Subaqueous Sanitary Sewer Replacement

ENGINEERING REPORT

**Town of Lake Lure
Lake Lure, North Carolina**

**May 2021
LaBella Commission No.: 2200559
SRF No. : CS370489-05**

Figure 2.5

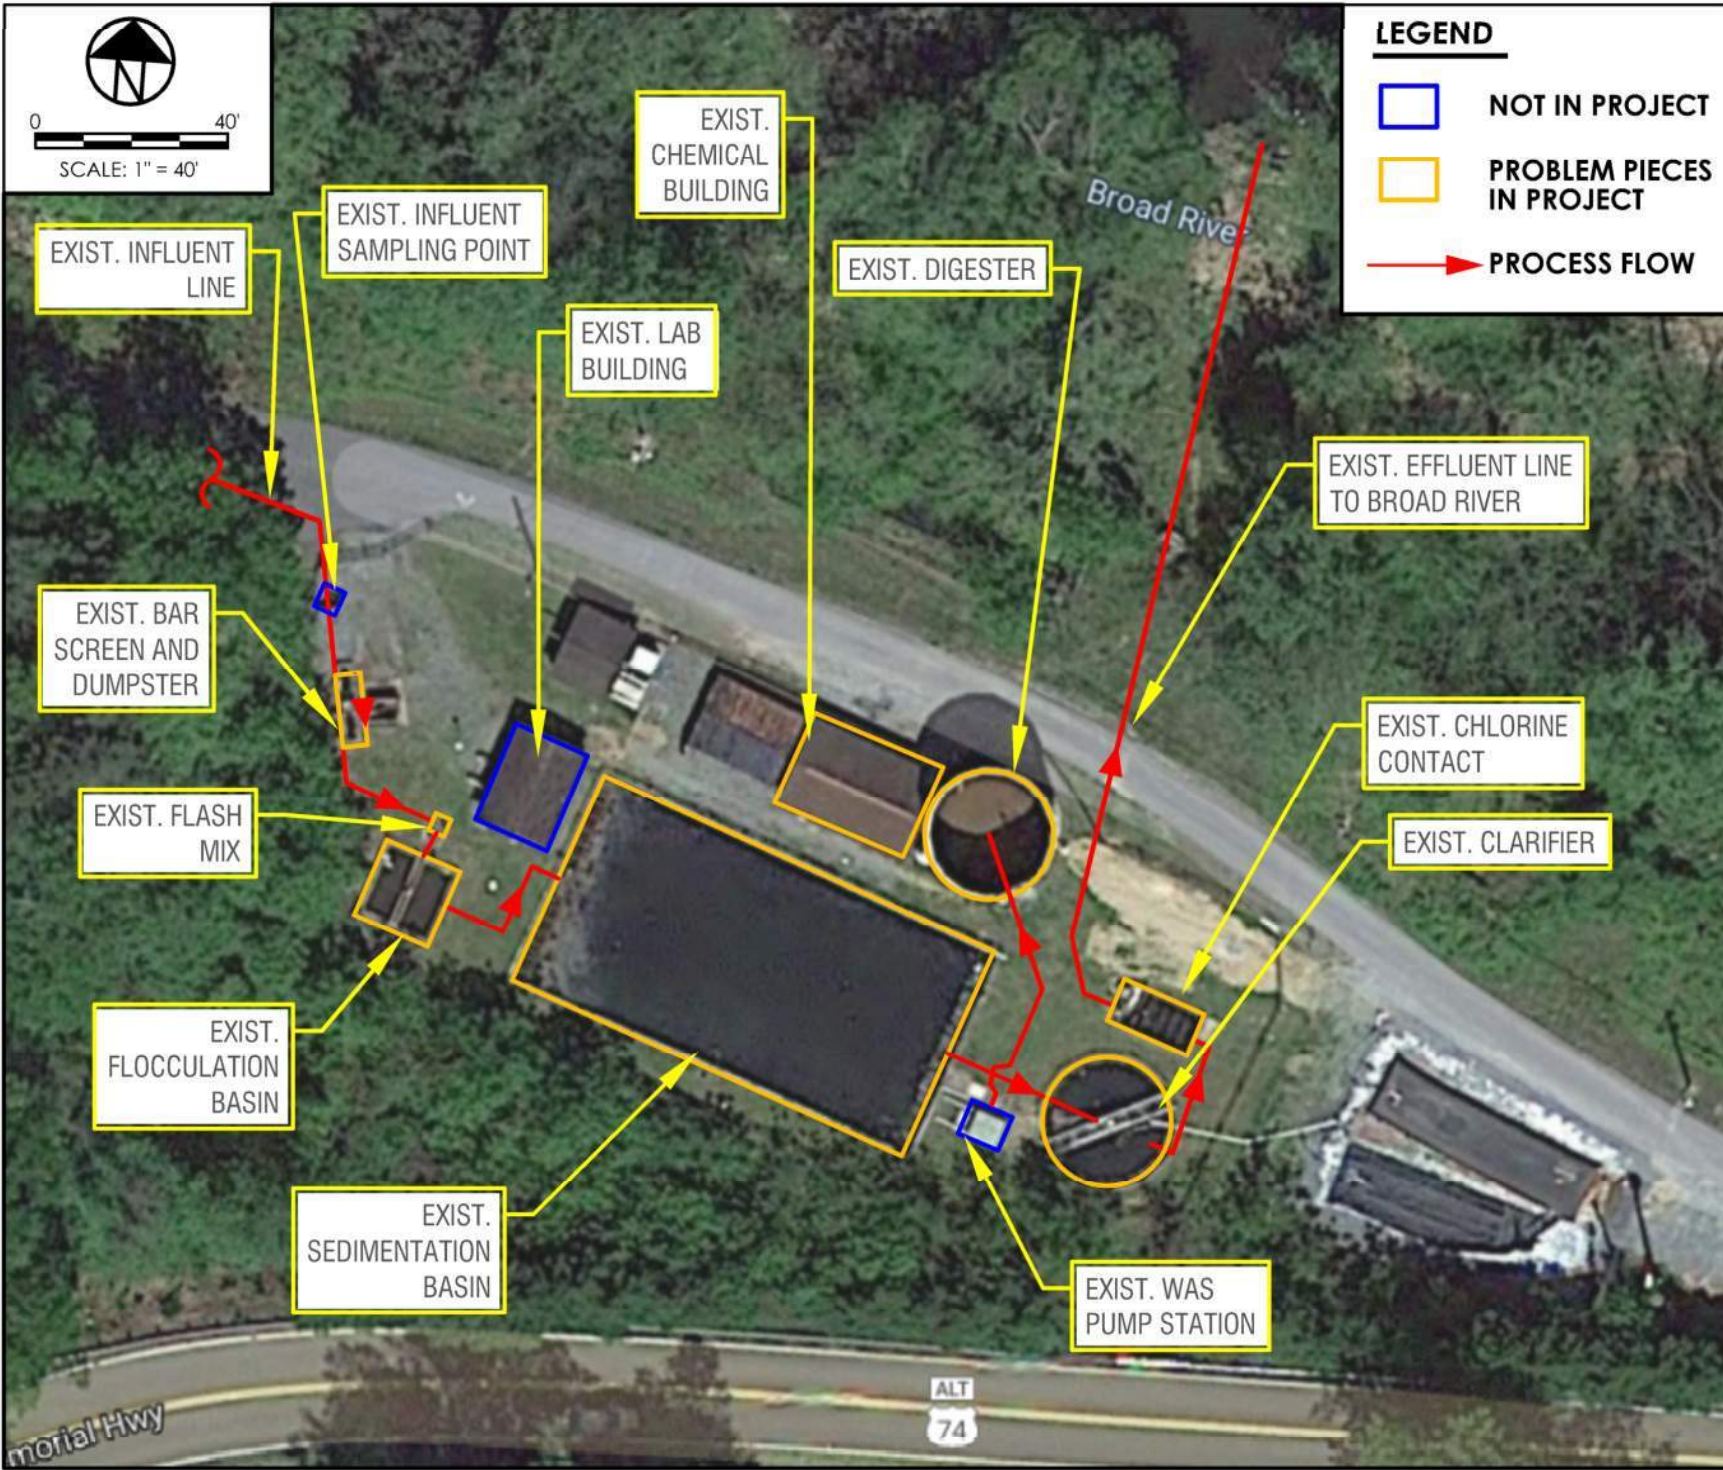
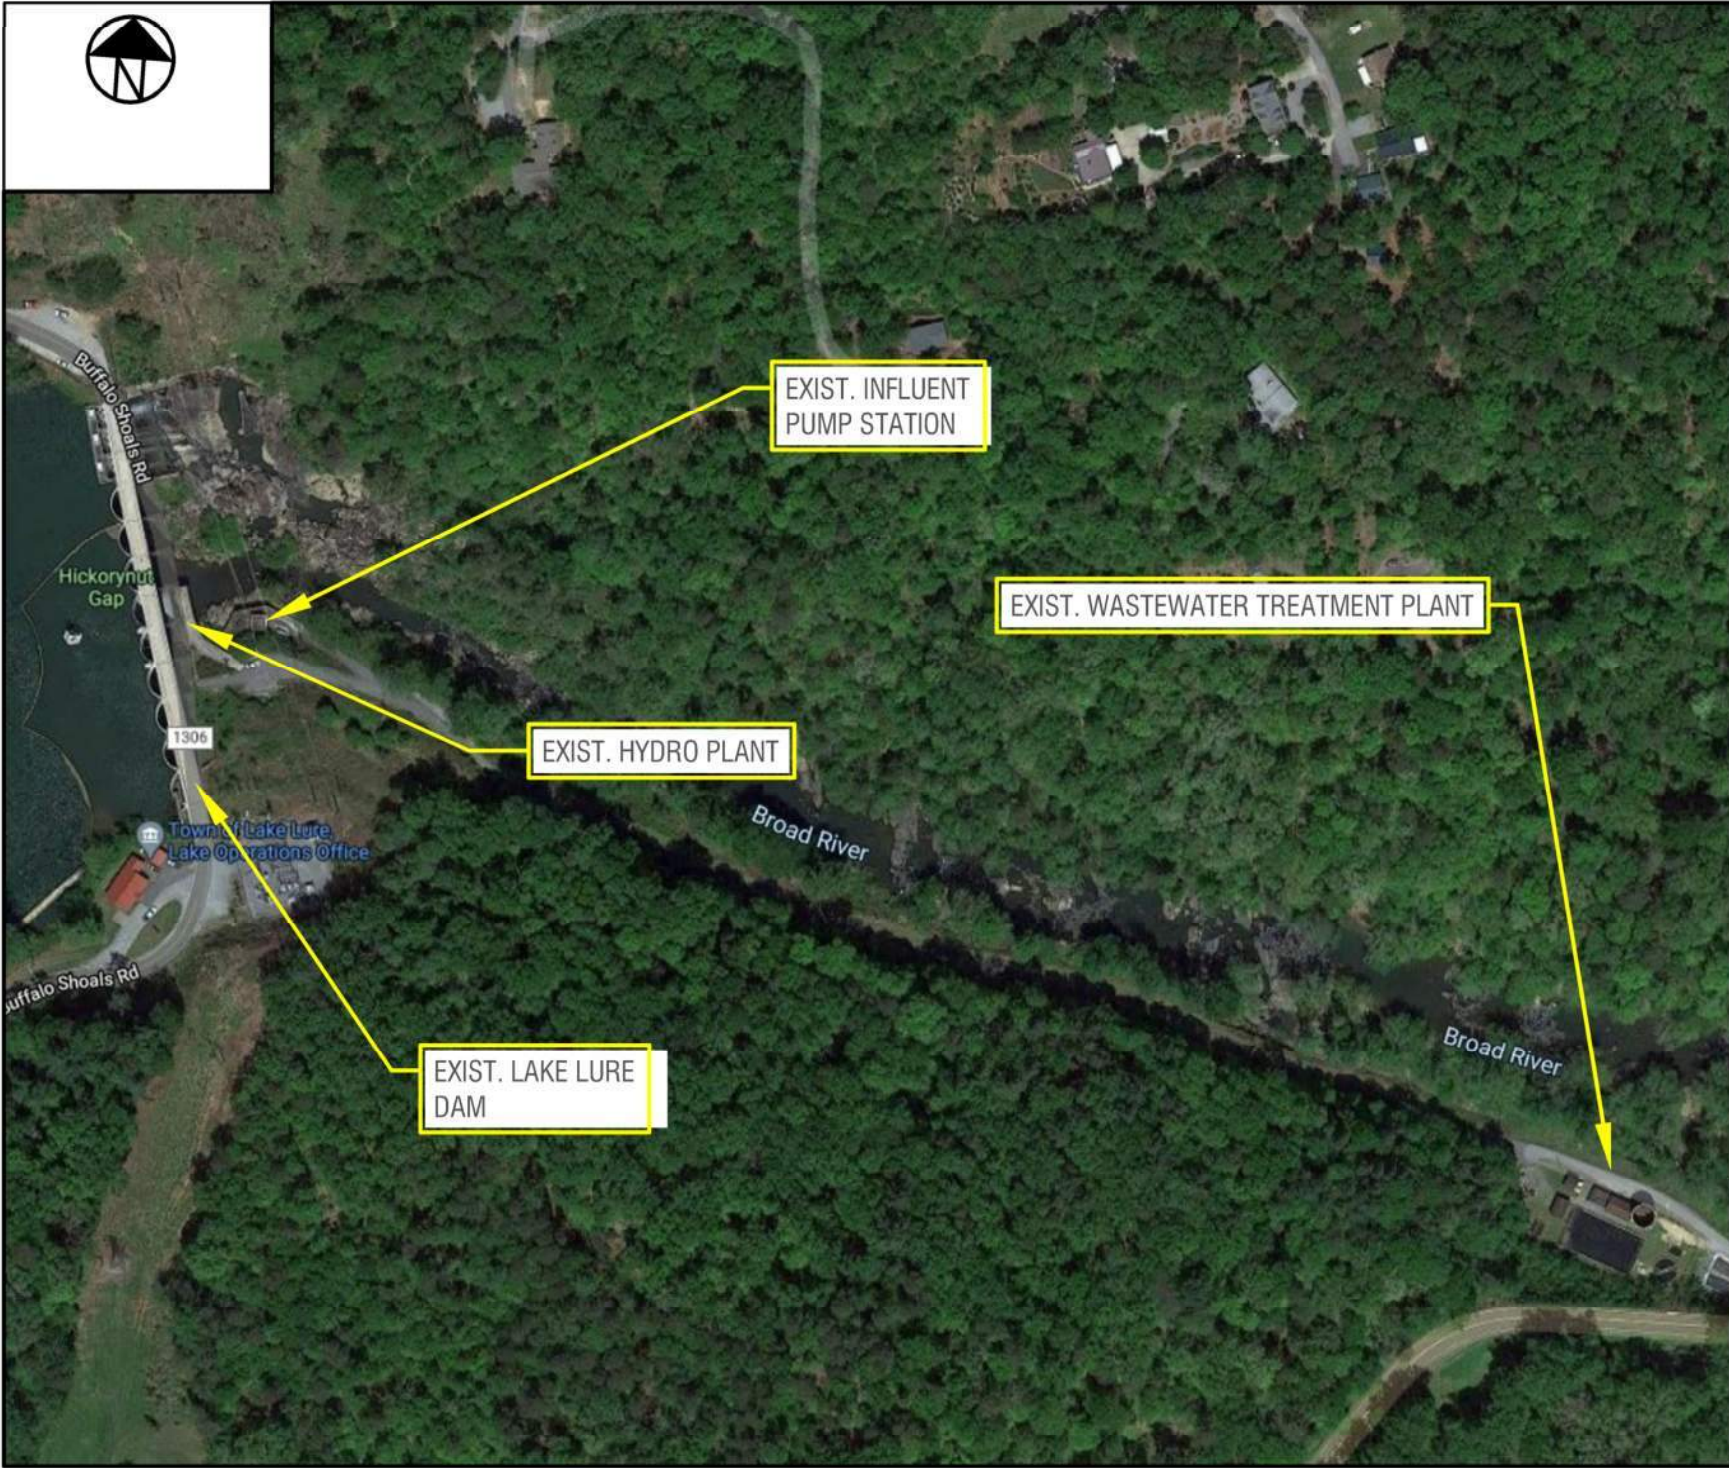
Comment Number	Original Comment	Comment By	Initial Response	Response By
B-6f	According to page 15, I&I from the lake is estimated at 0.43 MGD whereas page 24 mentions 0.4 MGD. Please correct this discrepancy throughout the report.	DWI T. Desai	This discrepancy has been corrected throughout the ER.	LaBella H. Miller
B-6g	Edit Figure 2.4 to show arrows pointing towards existing bar screen, flash mix, flocculation and sedimentation basins and pump station.	DWI T. Desai	Map has been updated	LaBella M. Walsh
B-6h	Add a figure to show the location of influent pump station in close proximity to Lake Lure Dam.	DWI T. Desai	Figure 2.5 has been changed to show the pump station and dam	LaBella M. Walsh
B-6i	Please remove Figure 2.4 or 2.5 if they are showing the same information.	DWI T. Desai	Figure 2.5 has been changed, see B-6h.	LaBella H. Miller
B-6j	Is there a bypass screen at the plant? Table 2.9.1 on page 31 does not clarify if the plant has one or two screens.	DWI T. Desai	The plant has only one screen, there is a line bypass but it is not screened. The table has been updated.	LaBella M. Walsh

FIGURE 7.11

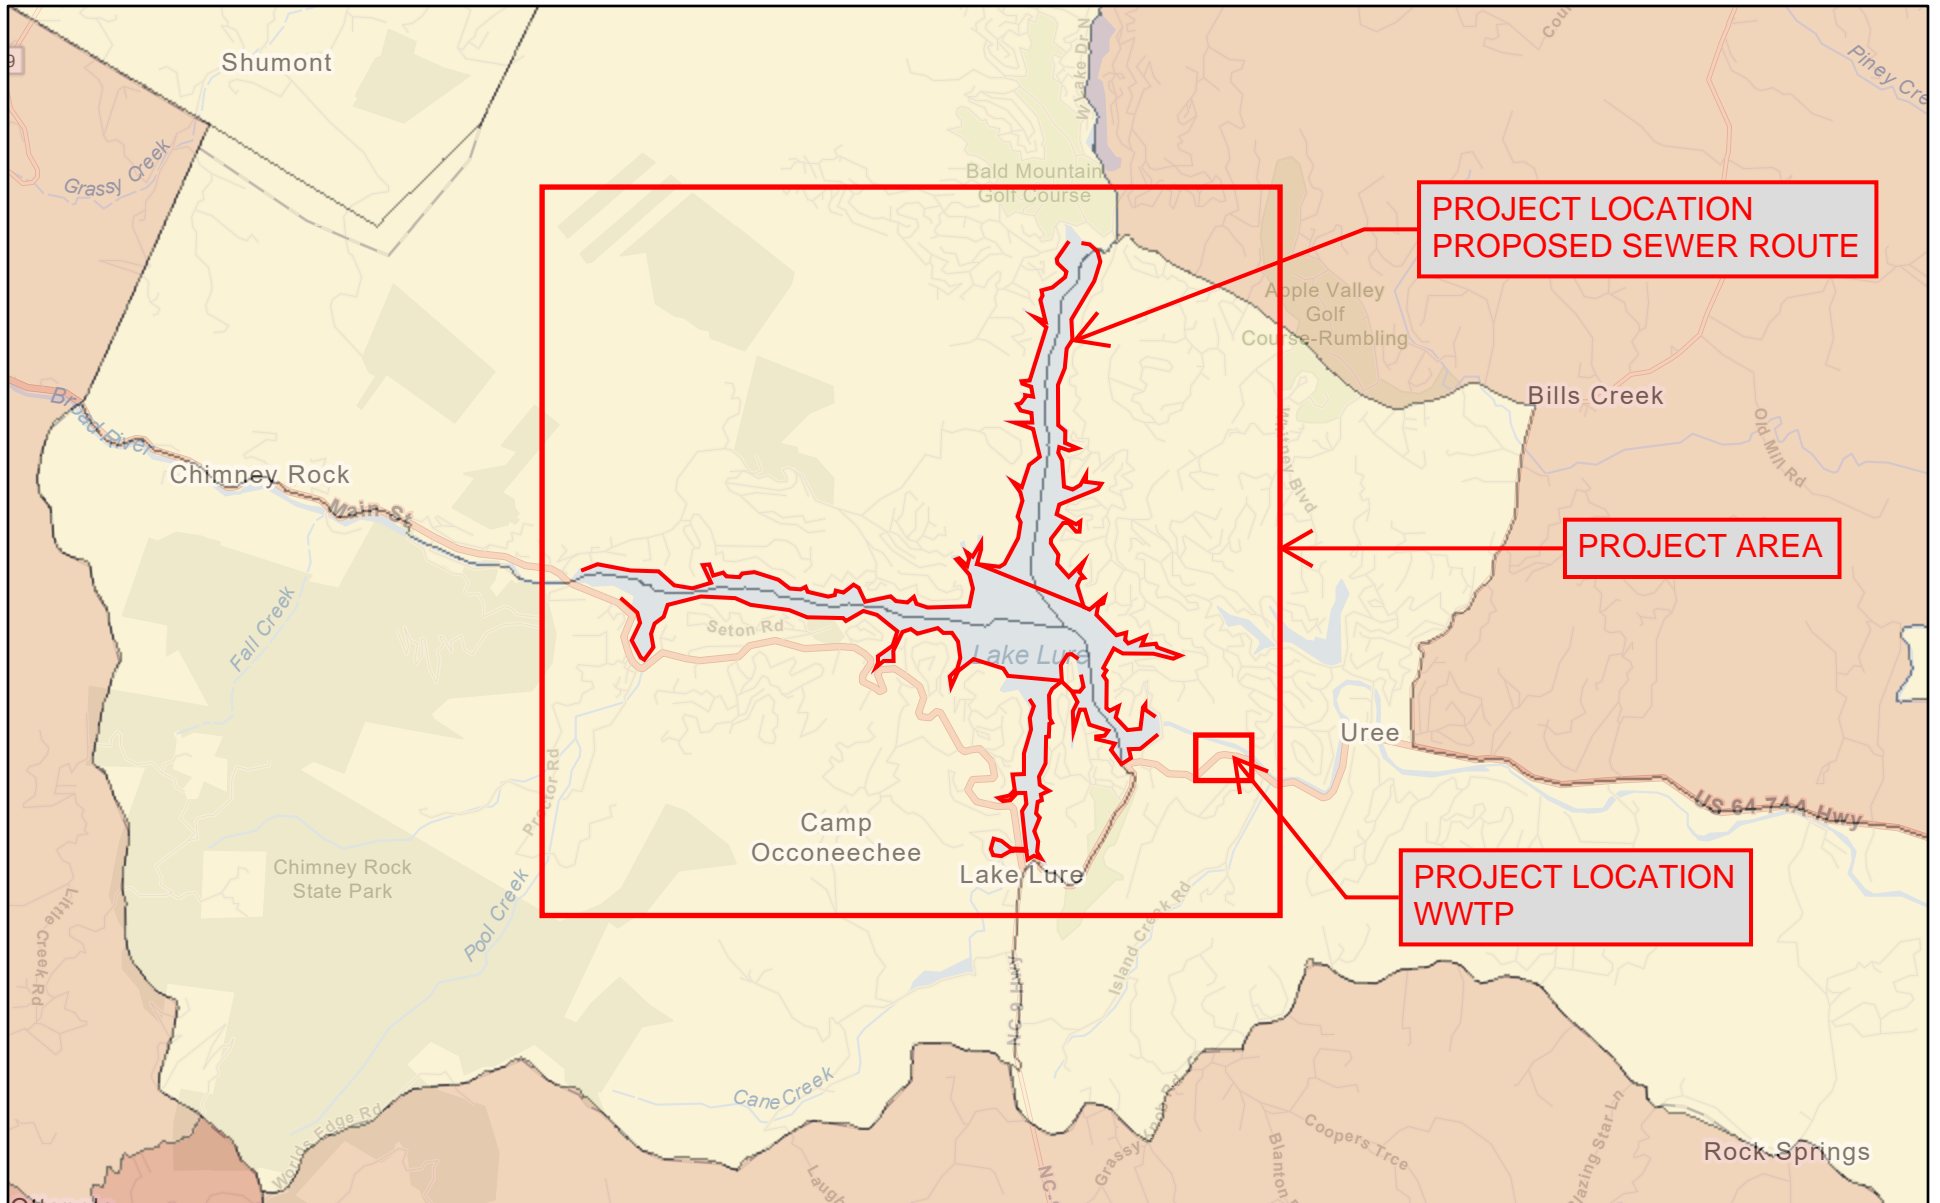
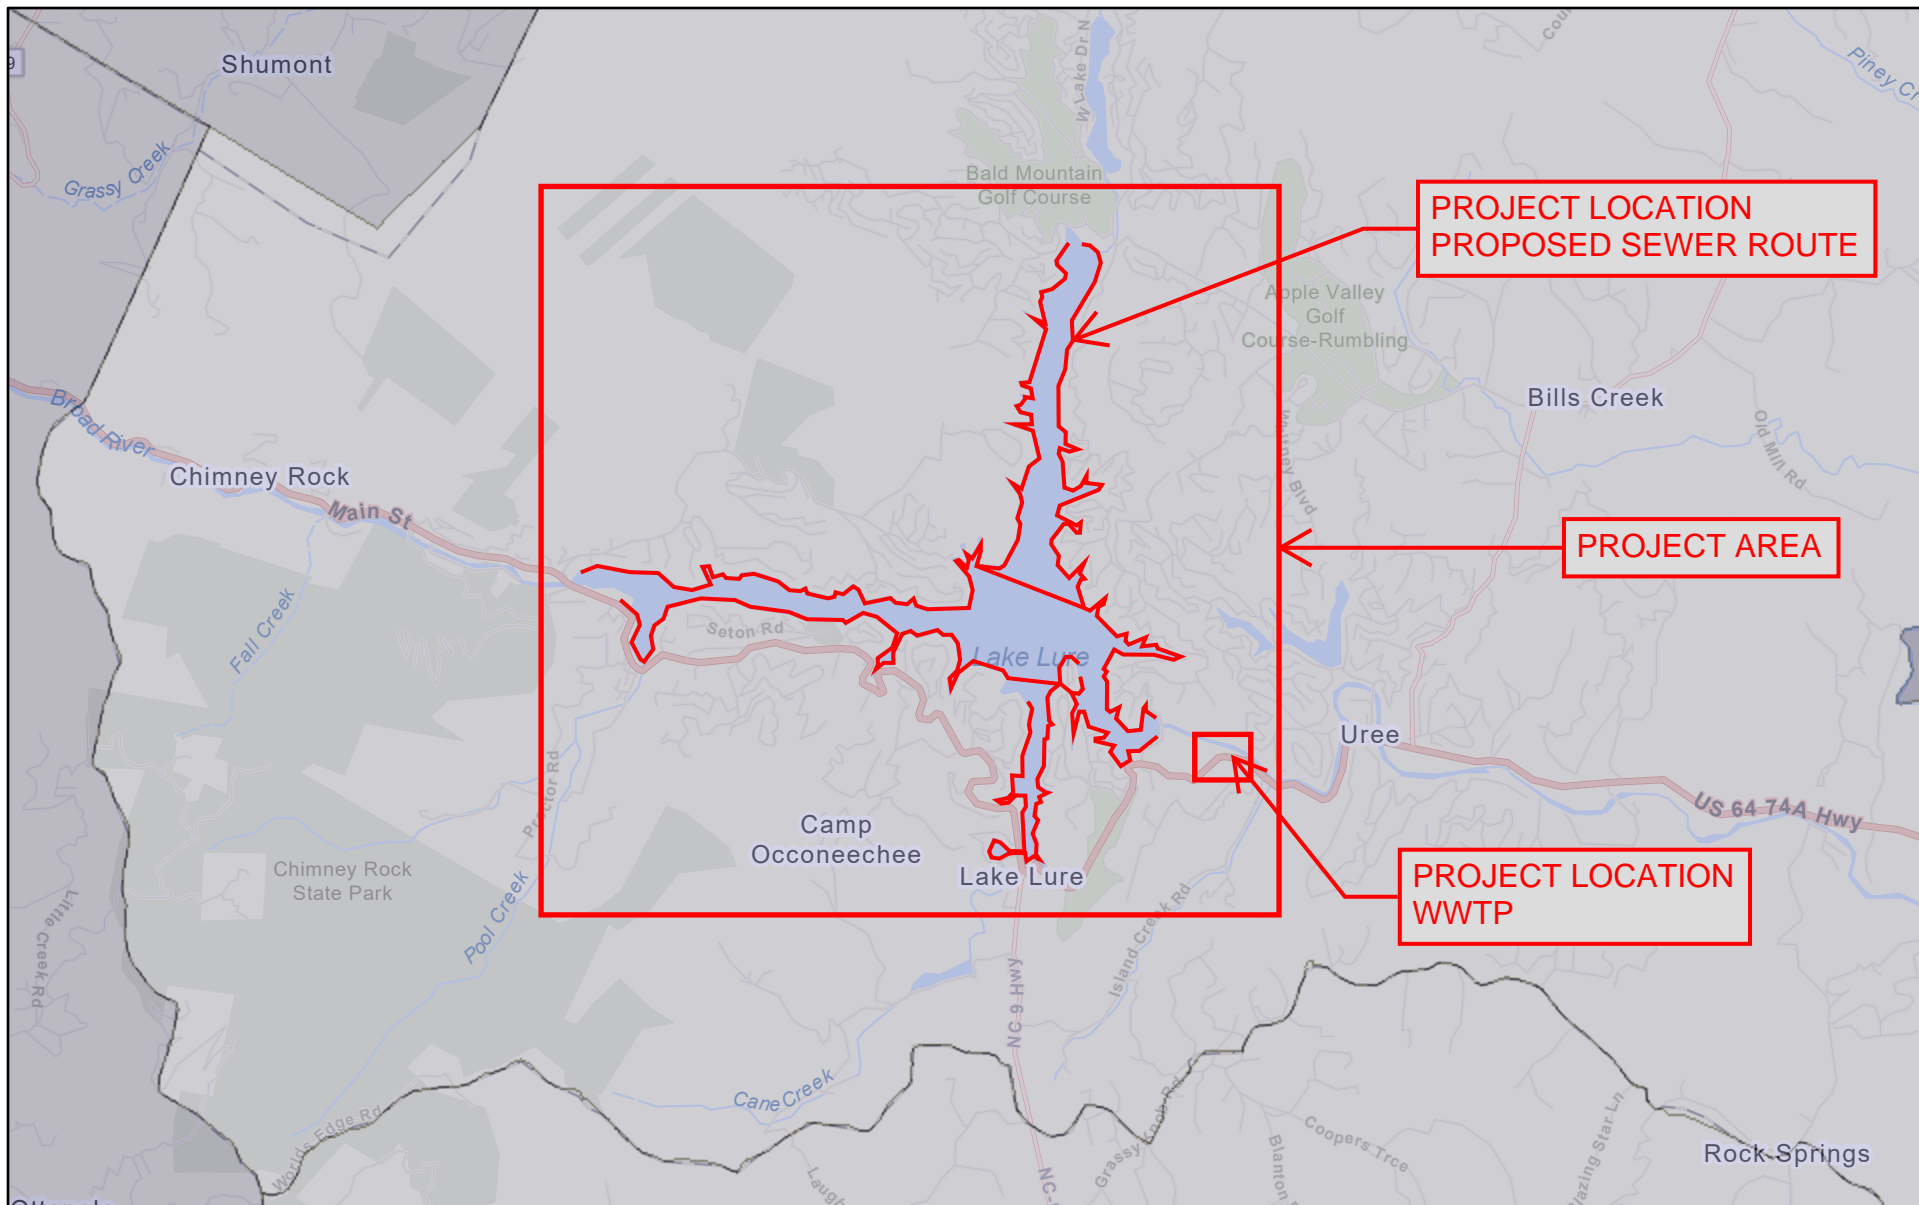
C-18a	Please provide the percentages (not percentiles) of low income and minority populations in the project area to clearly demonstrate whether there is a significant environmental justice population	DWI S. Kubacki	The figures do show percentages, not percentiles as generated by EJSreen: Environmental Justice Screening and Mapping Tool.	LaBella H. Miller
C-18b	The legends on Figures 7.11 and 7.12 are not legible. Please correct. (Disregard this comment if this is an issue only in the PDF version and not the printed document).	DWI S. Kubacki	There must be an issue in the .pdf version as the printed document shows the legends legibly.	LaBella H. Miller
C-19	Table 7.18 Mitigative Measures: Revise the table as needed to reflect any changes made in response to the preceding comments	DWI S. Kubacki	This table has been revised as needed.	LaBella H. Miller
C-20	Please review and address the attached comments from the DEQ review. Note that additional comments from cross-cutter review agencies (Fish & Wildlife Service) are anticipated shortly and will be forwarded as soon as they are available	DWI S. Kubacki	US Fish and Wildlife Service comments have been addressed.	LaBella H. Miller
